ADDENDUM NO. 1

PROJECT NAME: CHRISTENSON FACILITY HAIL DAMAGE REPAIR
UNL PROJECT NUMBER: SR 462906

CONSULTANT: UNL FACILITIES PLANNING & CONSTRUCTION
ADDRESS: 1901 Y STREET, LINCOLN, NE 68588-0605

DATE OF ISSUANCE: September 13, 2012
DATE OF BID OPENING: September 25, 2012

1 09/14/12
Attachment 1.04

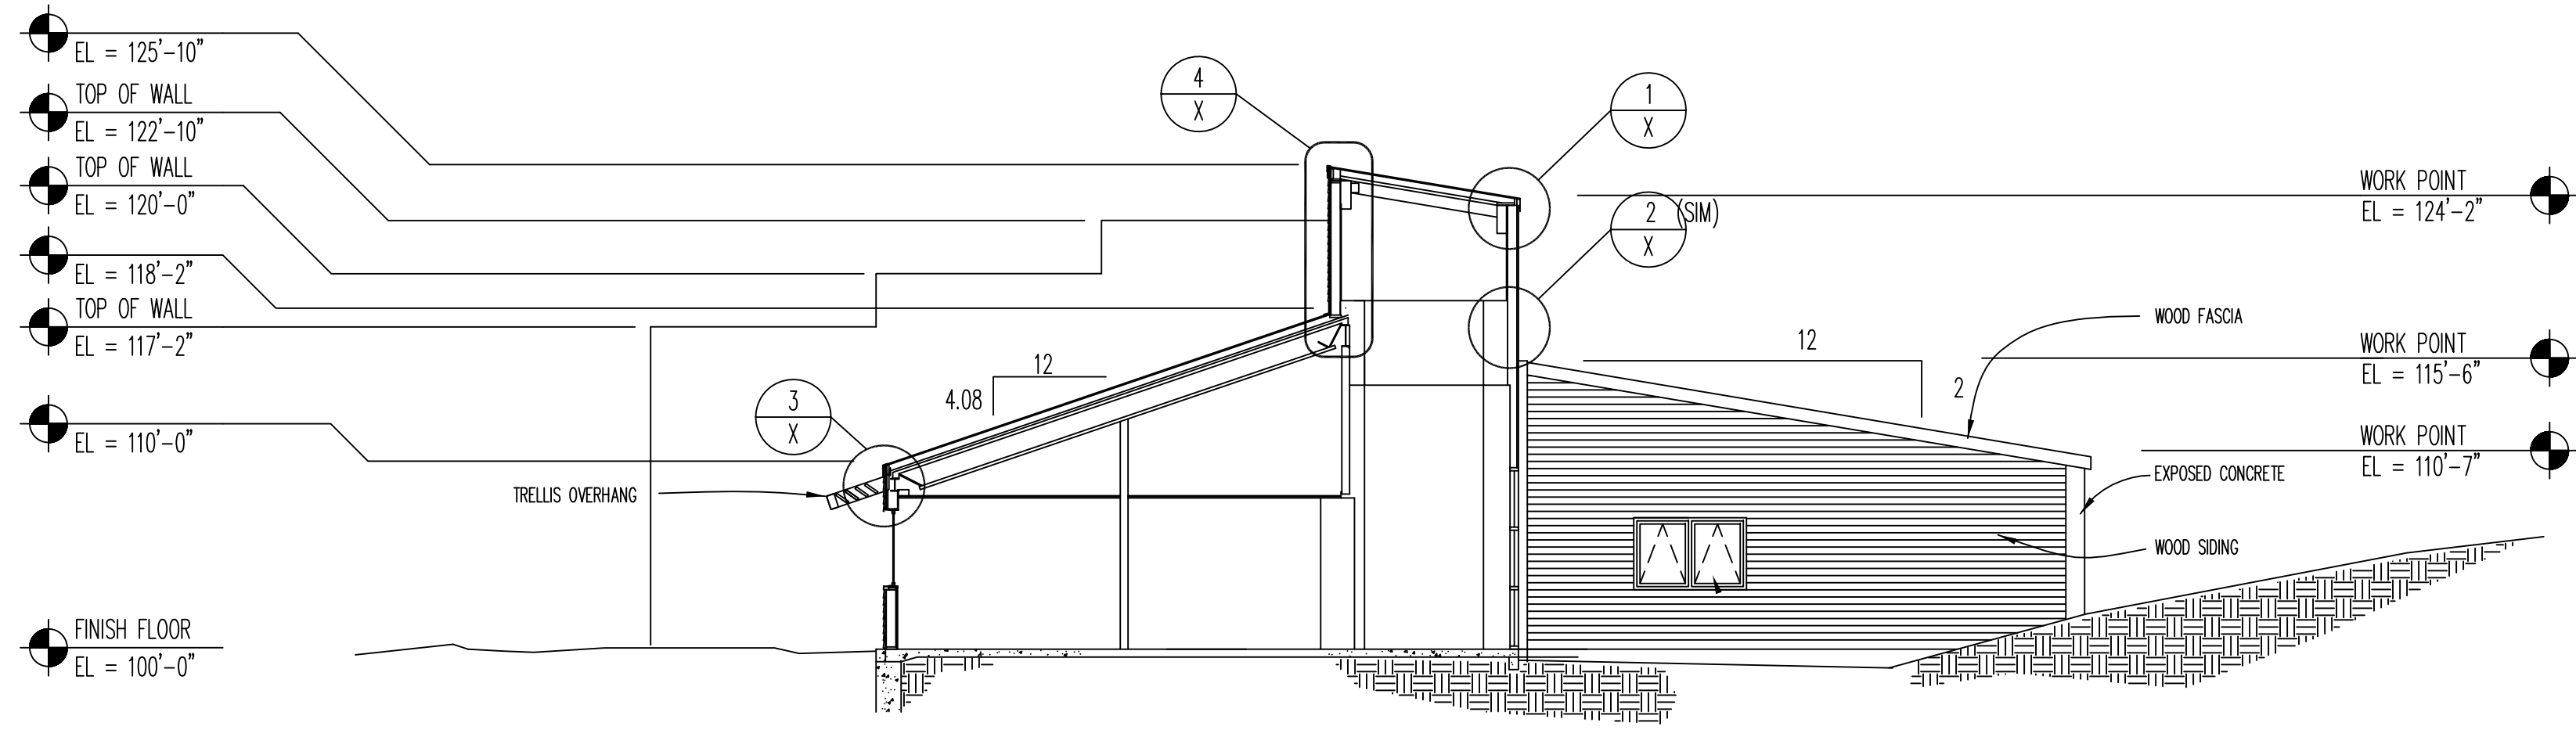
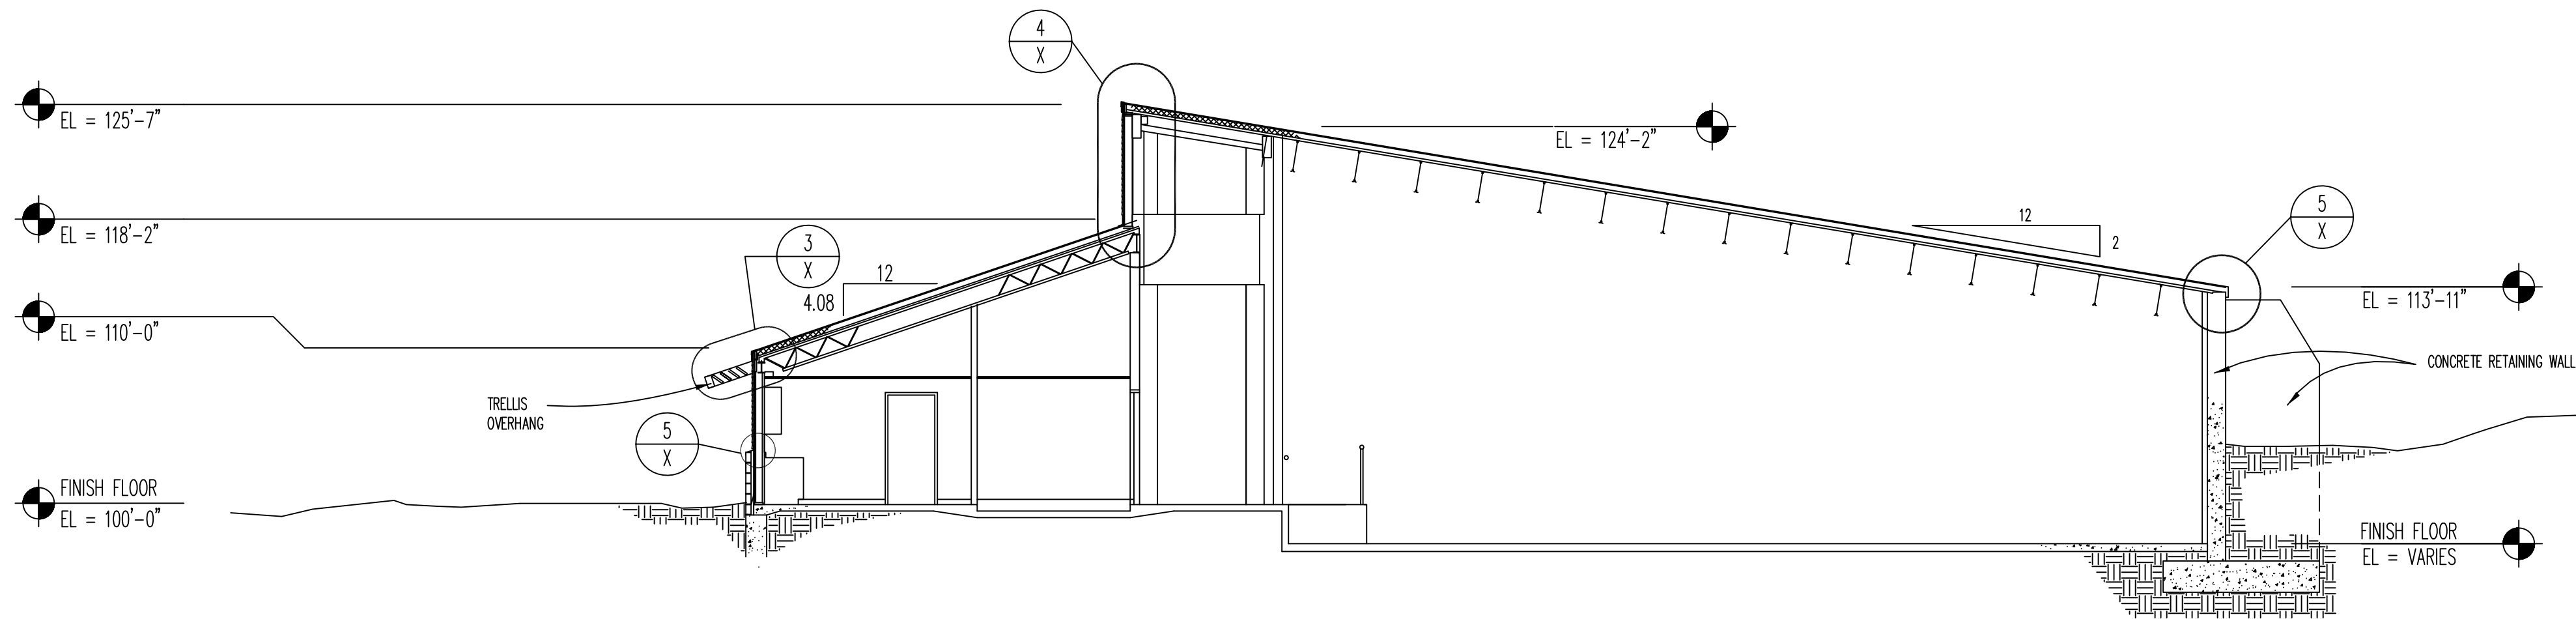
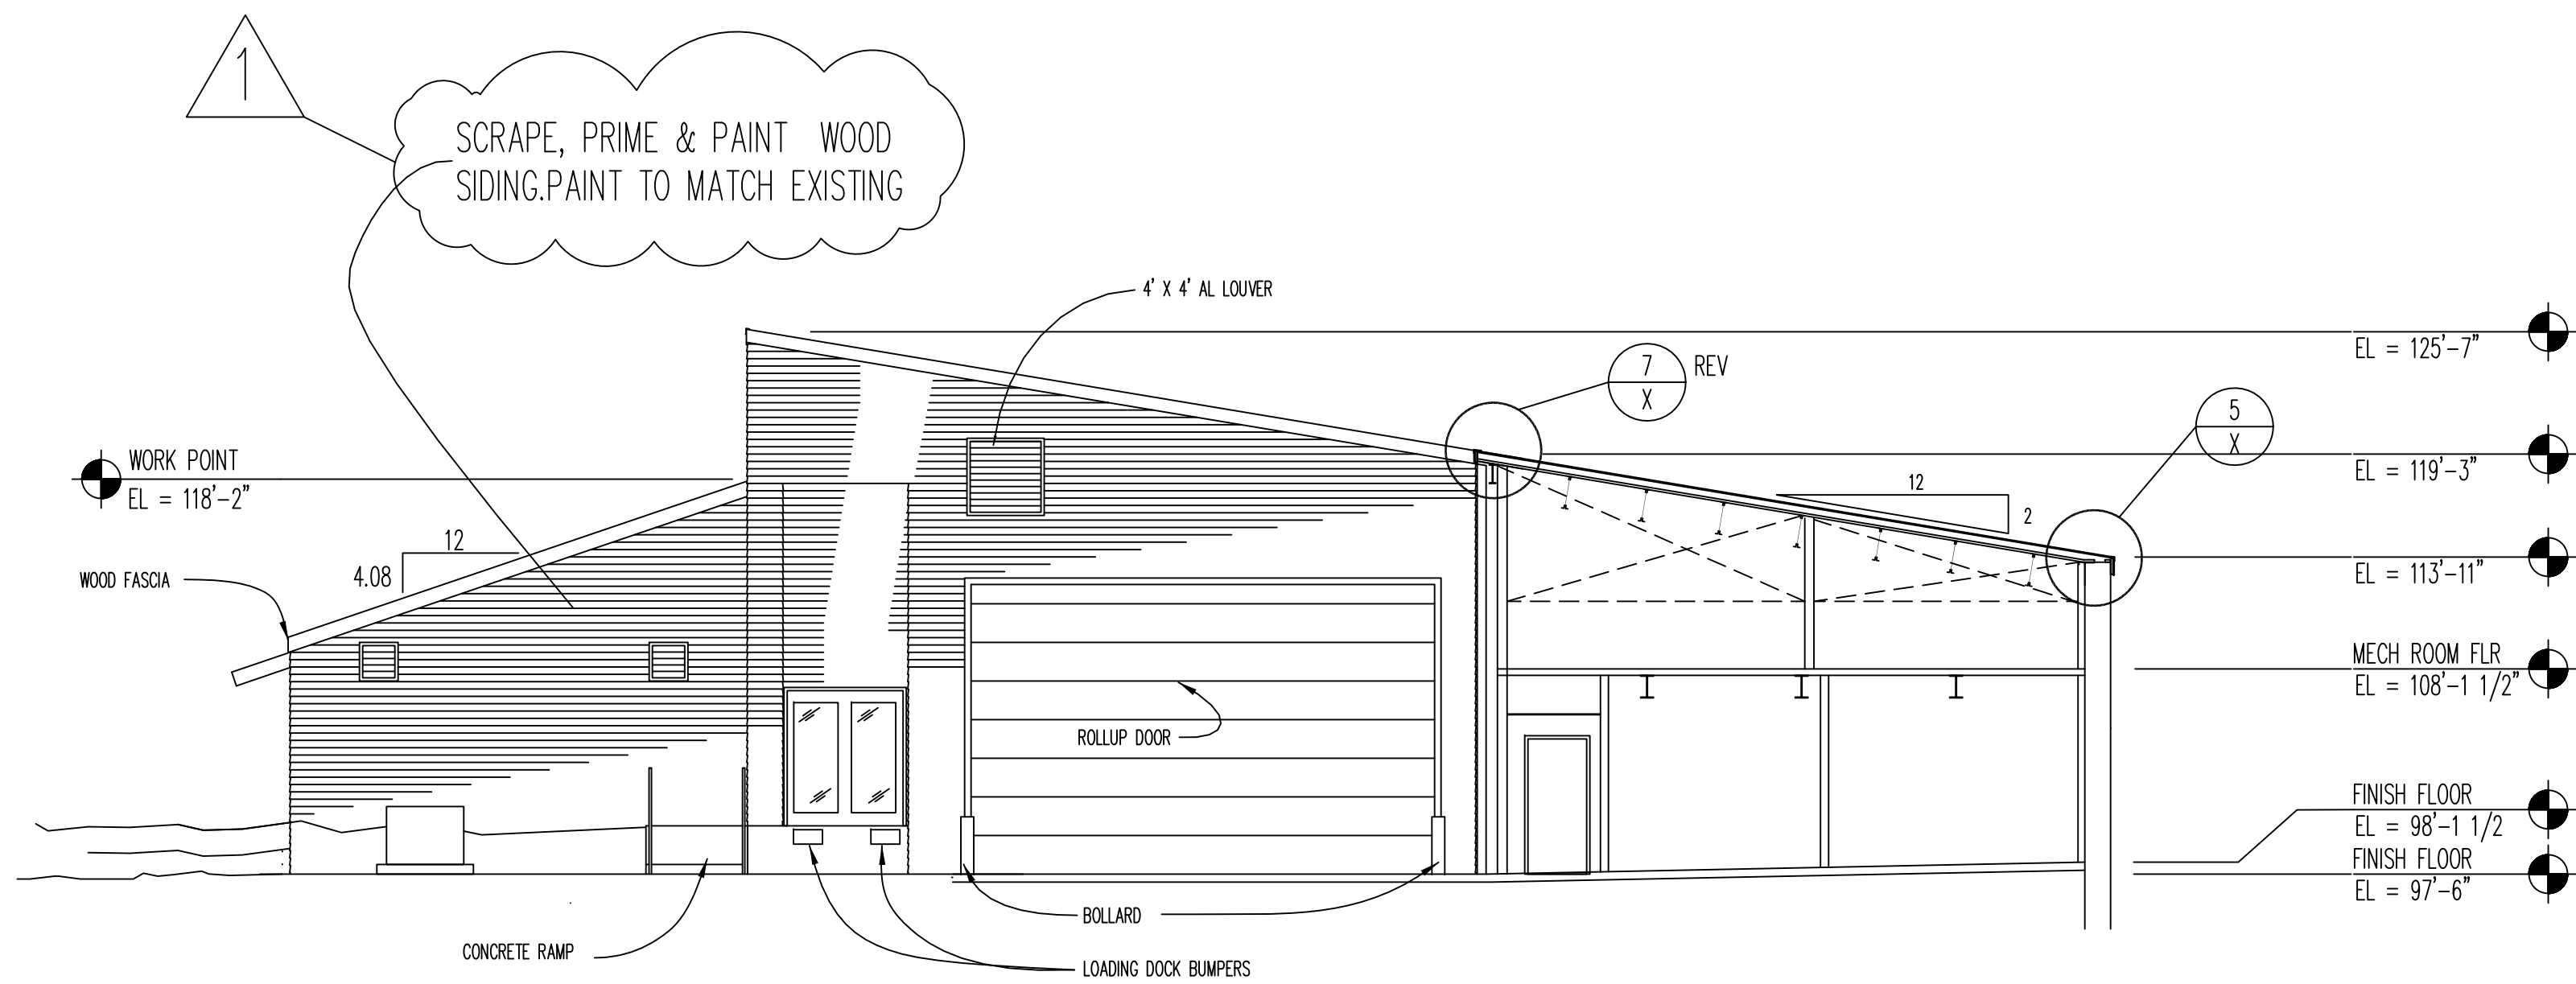
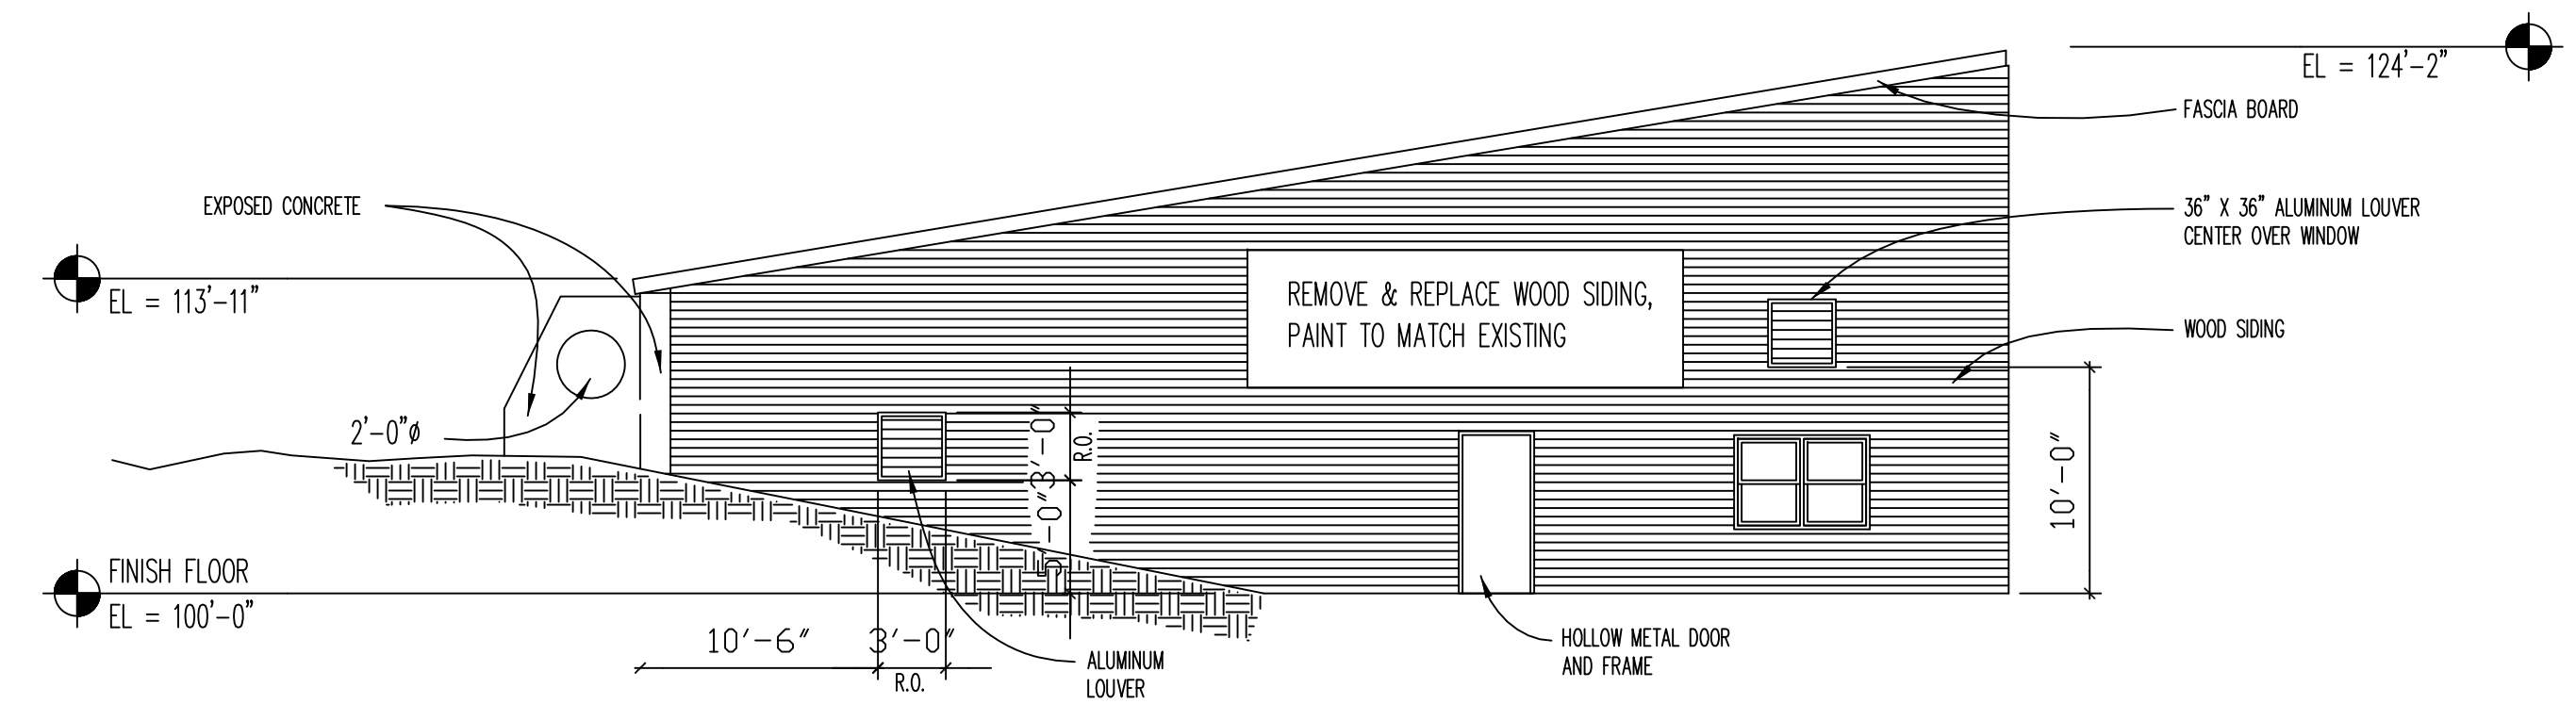
DRAWING NO A3.01

1. (Delete): Replace with attachment #1.04.

- #1: - Scrape prime & paint siding, fascia & trim; Entire South elevation **and East elevation of office area.**
See 4/3.01.
- #2: - Remove & replace existing 20 ton condensing coil(s), **shroud** and line set insulation for existing A/C; North elevation.
